Technical Service Bulletin

June 16, 2023

Michi Bluetooth 5.1 aptX™ HD Module

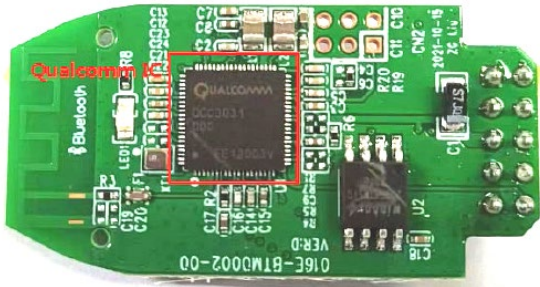
- Part Number of New Bluetooth Module 5.1 is **093E-BTM0002-D-3**
- New Bluetooth module 5.1 built Qualcomm IC as below photo.

If this is reported, please contact Rotel at sales@rotelglobal.com to order a new Bluetooth 5.1 module (Rotel Part Number: **093E-BTM0002-D-3**) with updated firmware V1.04 (or newer) that resolves this iOS compatibility issue.

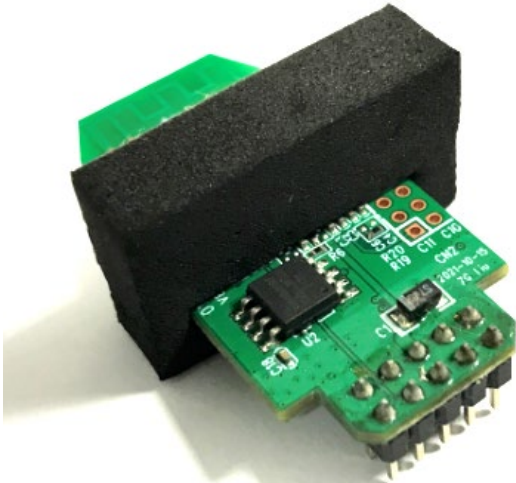
b. Remove the Bluetooth 5.1 dongle from the socket.

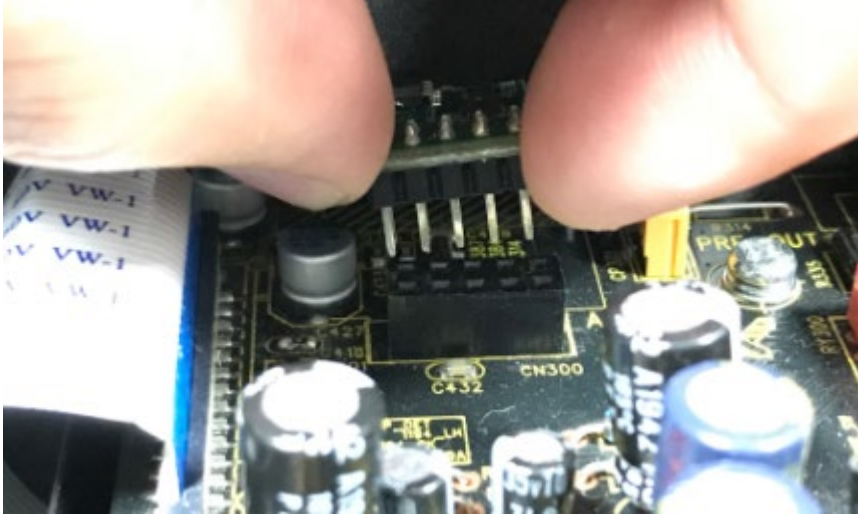
c. Prepare the new ordered Bluetooth dongle (with firmware V1.04 or higher installed)

- d. Install the new Bluetooth 5.1 dongle in the socket. Pay CAREFUL attention to pin alignment to avoid damage to the dongle and the unit.
